Subject: Dresden Station Units 2 and 3  
Quad Cities Station Units 1 and 2  
Response to Questions Concerning  
Mark I Containment Plant Unique Analysis  
NRC Docket Nos. 50-237/249 and 50-254/265

Dresden Station Units 2 and 3  
Quad Cities Station Units 1 and 2  
Response to NRC Questions 1 through 9  
on the Mark I Plant Unique  
Analysis Report

Response to NRC Question 10  
on the Mark I Plant Unique  
Analysis Report

Figure 1-1

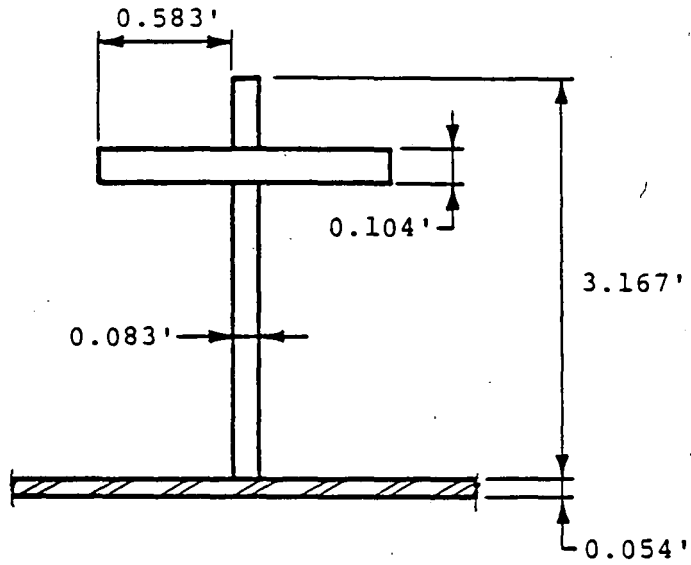
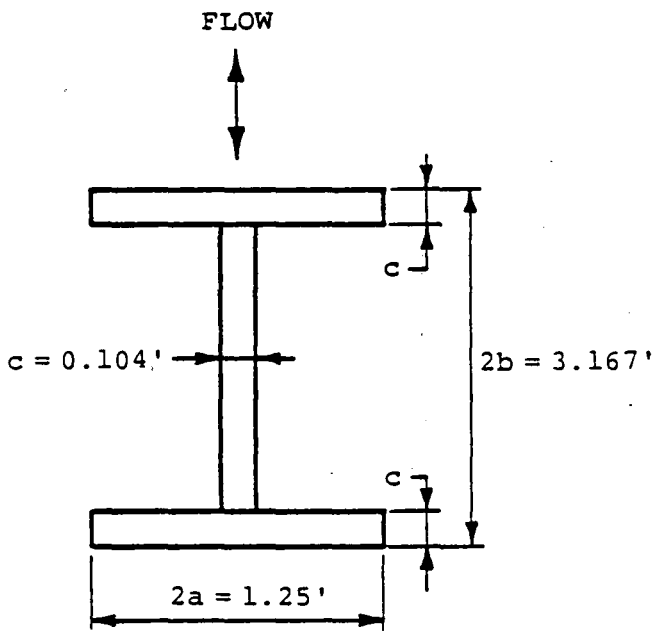
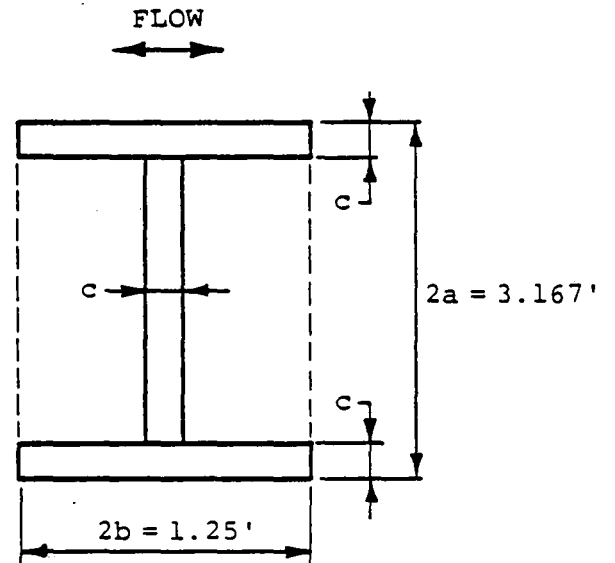
Acceleration volumes for structures with sharp corners such as I-beams are computed on the basis of values in Table 1-4.1-1 for pool swell, C.O., chugging and SRV loadings (Sections 1.4.1.5, 1.4.1.6, 1.4.1.7.3, 1.4.1.8.3 and 1.4.2.4). The stated use of Table 1-4.1-1 is clearly not possible directly as the shapes and flow directions presented do not match any realistic model of some structures such as the ring girder. For Segments 7, 8, 9 and 10 of the ring girder (Table 2-2.2-9 in the Dresden PUAR and Table 2-2.2-11 in the Quad Cities PUAR) give the specific formulas and values of the acceleration volumes for loads in the direction normal to the flange and normal to the web. For post-chug loads shown in Table 2-2.2-9 of Dresden and Table 2-2.2-11 of Quad Cities, identify the chugging downcomers and the phasing relationship and give the local acceleration components at Segments 7, 8, 9 and 10 of the ring girder due to unit source strengths.

Figures 1-1 and 1-2 show the actual geometry of the ring girders and the models used to calculate the acceleration volumes for the

For the in-plane direction (normal to the flange) the ring girders were modeled as I-beams and the formula used to develop the acceleration volumes (Table 1-4.1-1 or K.T. Patton, reference 1-6.0-11. is Quad Cities and Dresden PUARs) for Segments 7 through 10 is:

The dimensions a, b, and c are shown in Figures 1-1 and 1-2. The distance L is the segment length for Segments 7 through 10;  $A_w$  is the factor to account for wall interference effects.

For the out-of-plane direction, the acceleration volumes for the ring girders were based on the hydrodynamic volume (Table 1-4.1-1

Figure 3-1

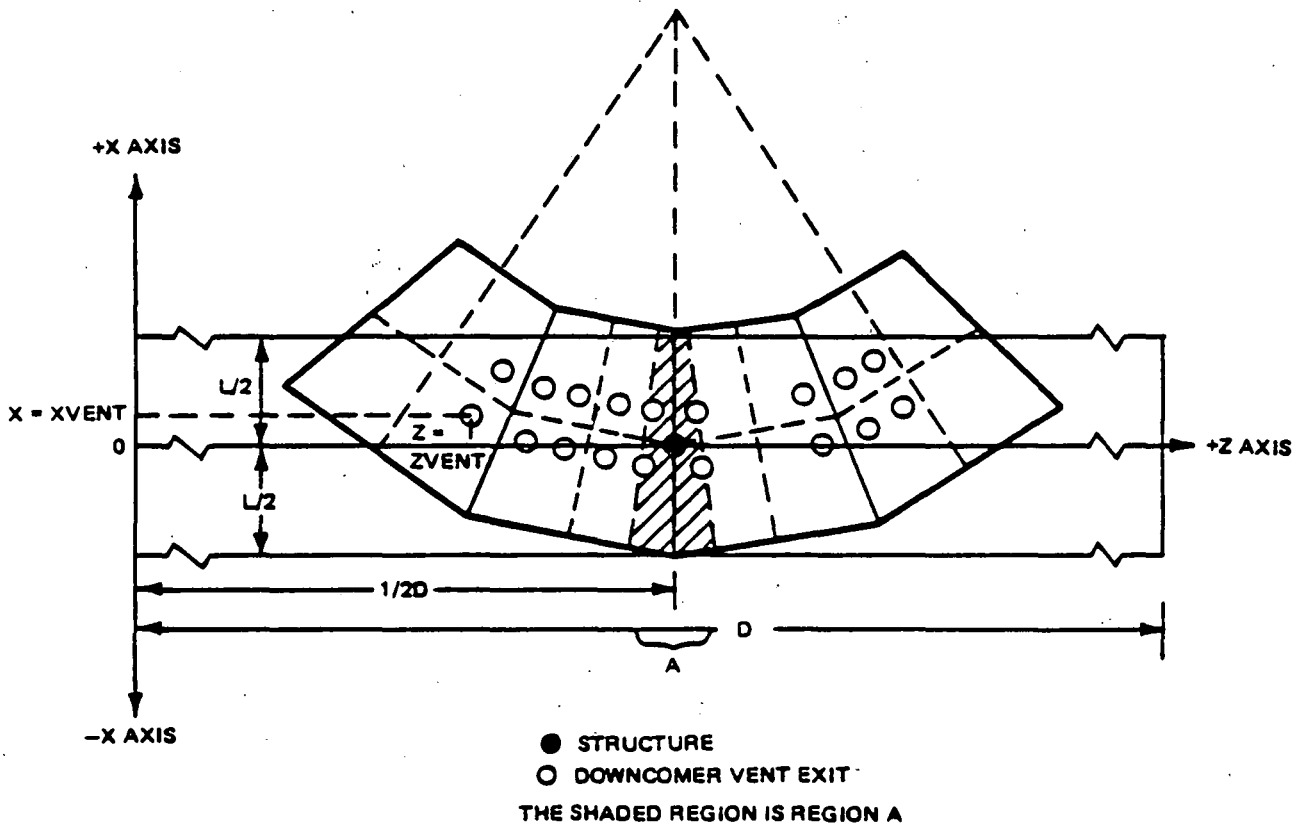
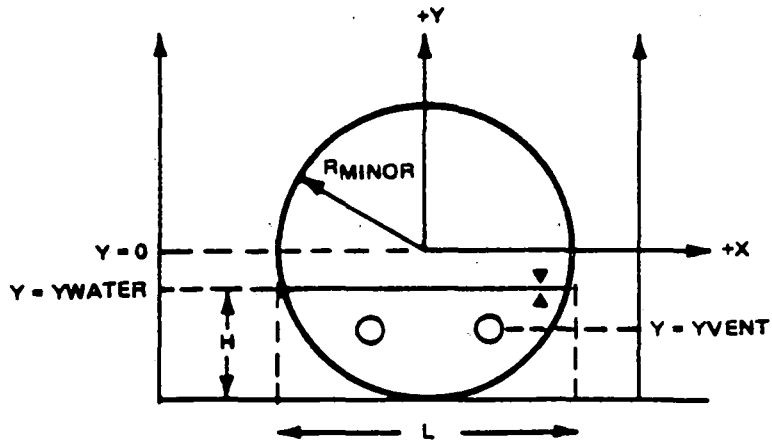
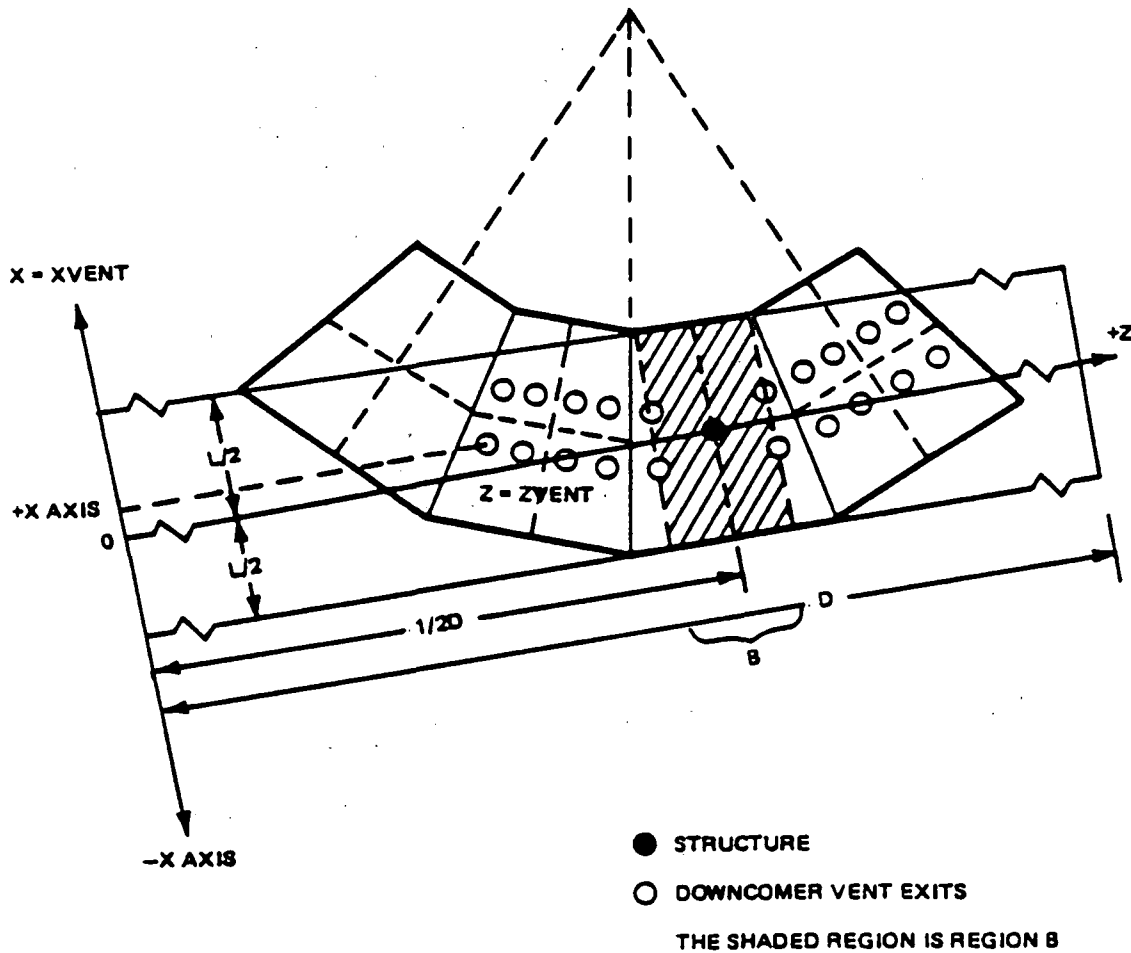
Submerged structure loads require a computation of the velocity and acceleration fields computed on the basis of the method of images applied to a model of the torus bay. Table 1-4.1-2 gives the relevant parameters for the rectangular bay model used for LOCA bubble drag loads. Is the same model used for CO, chugging and SRV loads on submerged structures? If yes, justify the use of this model for structures near the bay boundary (e.g. ring girder, vent header support column) under asymmetric loading conditions, i.e. sources acting in one bay only. If not, describe in detail the models used.

The rectangular bay model for CO, chugging and SRV loads on submerged structures is similar to that used for LOCA bubble drag loads. As required in Appendix A of NUREG-0661, Model E in NEDE-21983-P is used for the method of images simulation of the torus cross-section for LOCA air bubble, CO, chugging and SRV analyses. The length of the bay model for LOCA air bubble analysis is equal to one actual bay.

Structures may be close to the bay boundary. However, for the CO, chugging and SRV analyses, structures are always placed at or very near the center of the rectangular bay model ( $\frac{1}{2} D$ ) as shown in Figures 3-1, 3-2, 3-3, and 3-4. From these figures it can be seen that the torus is unwrapped to a length  $D$  which is equal to the torus circumference ( $D = 2\pi R_{\text{major}}$ ,  $D_{\text{Quad Cities and Dresden}} = 342 \text{ ft}$ ). Hence, structures are never near the bay boundary and asymmetric loading conditions. Thus, sources acting in one bay only are readily accommodated.

Figure 4-1

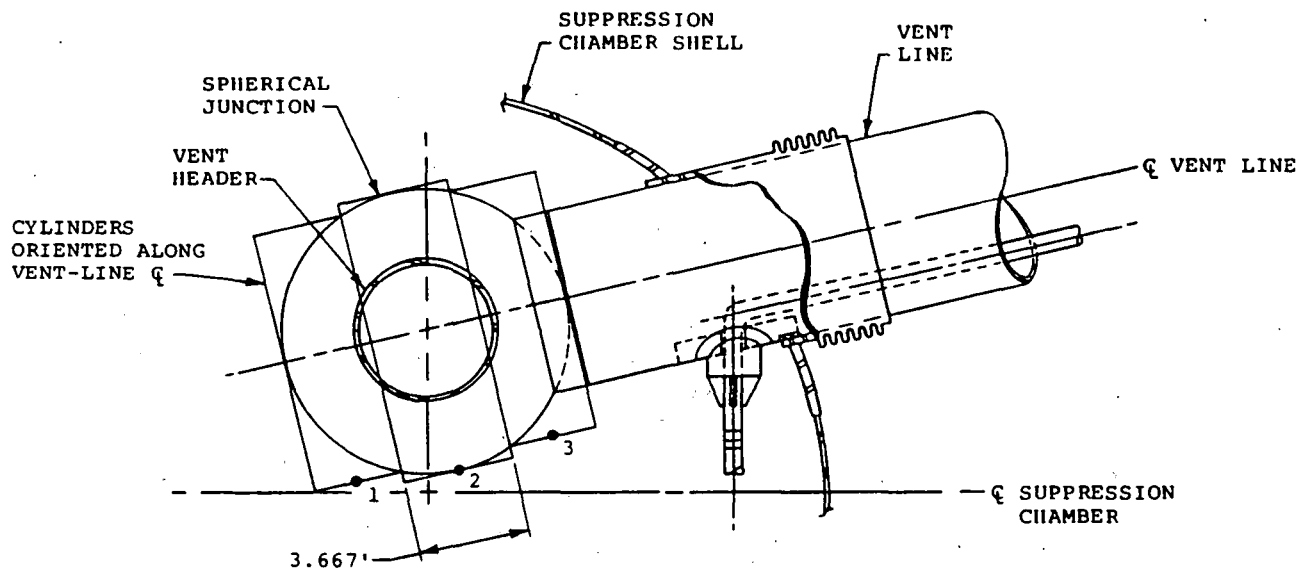
The PUAR (Section 1.4.1.4.1) states that pool swell impact and drag loads on the main vent-vent header spherical junction are computed according to procedures specified in Appendix A of NUREG-0661. Since no specification is given for spherical structures in Acceptance Criteria, describe which procedure in Appendix A of NUREG-0661 is used and how the spherical junction is modeled.

The procedure described in Section 2.6 of Appendix A of NUREG-0661 was used to evaluate the pool swell impact and drag loads on the spherical junction for both Quad Cities 1 & 2 and Dresden 2 & 3.

The spherical junction was modeled by a series of cylinders whose axis is along the centerline of the main vent. The spherical junction was subdivided into three equally wide cylinders such that the width is approximately one-third of the diameter, as shown in Figure 4-1. Since the procedure used is that defined for the main vent, the force transient calculated included both acceleration drag and buoyancy. In addition, the velocity drag

was calculated using a conservative value of  $C_D$  equal to 2.0, and the projected area of the cylinders, which is larger than that of the sphere.

Figure 6-1

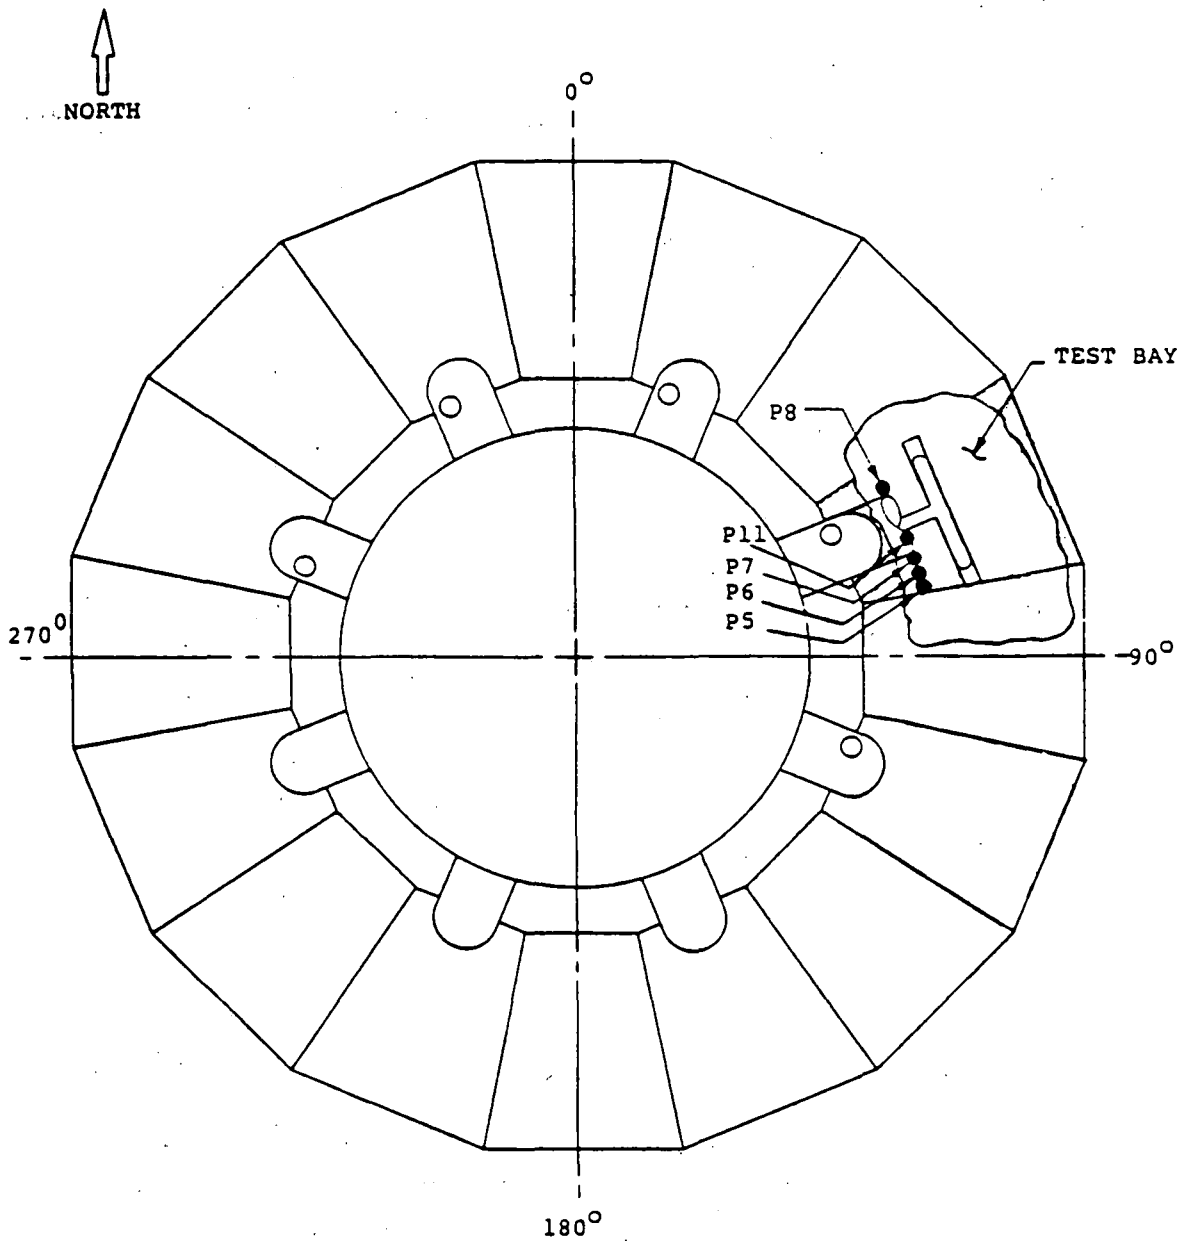
SRV torus shell loads are based on a modified analytical model that is calibrated to bound observed shell pressures in Monticello tests (Section 1-4.2.3). Additional vertical load correction factors are also deduced from Monticello tests. In-plant tests at Dresden Unit 2 are referenced as providing additional confirmation that computed loadings and predicted structural responses are conservative. Provide information on the number of tests performed and the observed maximum shell pressures as well as the predictions of the modified analytical model.

Attached Table 6-1 presents the test matrix for the Dresden Unit 2 SRV in-plant test. A total of eight tests were conducted for two different sets of initial conditions. Four tests were conducted for first SRV actuation (cold pipe) and four tests for second SRV actuation (hot pipe). The locations of the torus shell pressure transducers are shown in Figures 6-1 and 6-2. Tables 6-2 and 6-3 present the maximum observed and predicted shell pressures for single valve and consecutive valve actuation cases. These tables demonstrate conservatism in the analytical procedure used in generating torus shell loads.

Figure 7-1

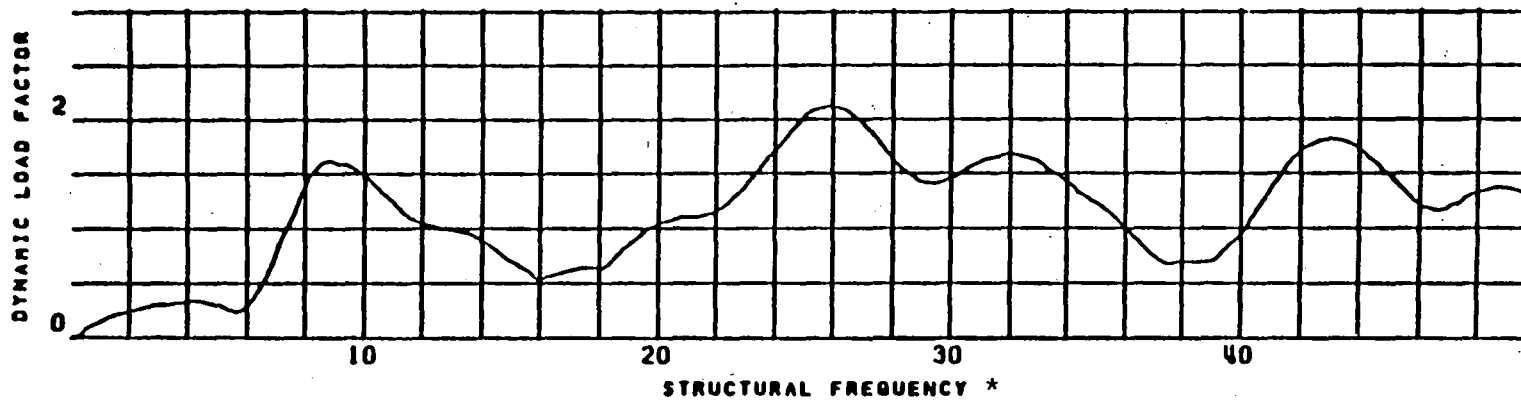
SRV drag loads are computed in accordance with the LDR, but "Dynamic load factors are derived from Dresden's in-plant SRV test data for both Quad Cities and Dresden" (Section 1.4.2.4). Explain exactly how these factors are used and give their numerical values for the major structural components, e.g. for the ring girder and the vent header support column. Describe how test condition information is extrapolated to design conditions, especially those involving multiple valve discharges.

As permitted by NUREG-0661 (Section 3.10.2.13), Dynamic Load Factors (DLF) for SRV bubble drag submerged structure loads were calculated using SRV discharge bubble pressure time histories measured during the Dresden Unit 2 SRV in-plant test. These bubble pressure time histories were applied to a damped single-degree-of-freedom model. Attached Figure 7-1 is a typical DLF versus structural frequency plot for these pressure time histories.

All submerged structures (e.g., ring girder, vent header support columns, etc.) were analyzed using a bounding DLF of 2.5 times the maximum calculated design bubble pressure loads. The DLF values at resonant condition were developed from the measured pressure-time histories at test conditions and were applied to the design basis event conditions as permitted by NUREG-0661, Section 3.10.2.13.

Table 8-1

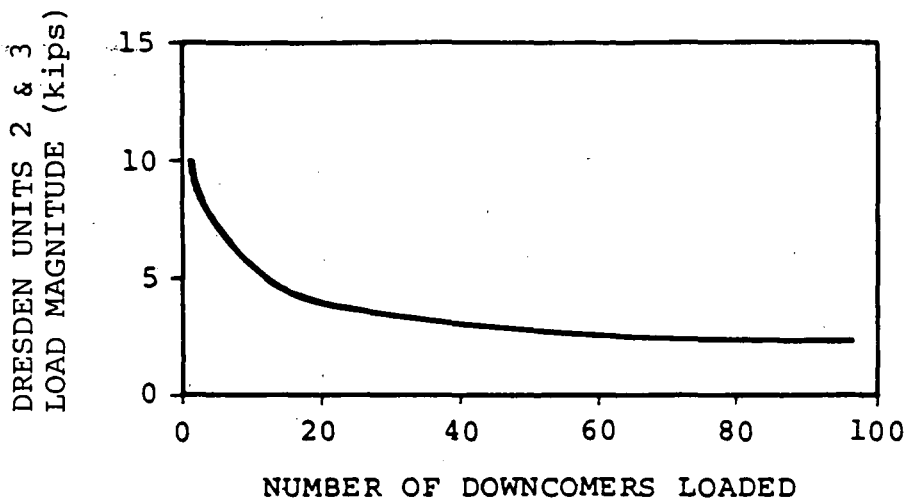
Table 3-2.2-15 of the Dresden PUAR (Table 3-2.2-16 of the Quad Cities PUAR) is inconsistent with Figure 1-4.1-23 of the PUAR. However, the loads as listed in Table 3-2.2-15 (3-2.2-16) are very conservative. Are the loads and downcomer groups as listed in the table(s) the ones used for analysis in Dresden and Quad Cities? Presumably the table heading "Quad Cities Unit 1 & 2 load per Downcomer" of Table 3-2-2-15 of the Dresden PUAR is mislabeled.

The table and column headings in Dresden PUAR Table 3-2.2-15 are mislabeled. The number of downcomers listed in this table and Quad Cities PUAR Table 3-2.2-16 are also mislabeled. Tables 8-1 and 8-2 present the loads and downcomer groups used in the Dresden and Quad Cities Plant Unique Analyses.
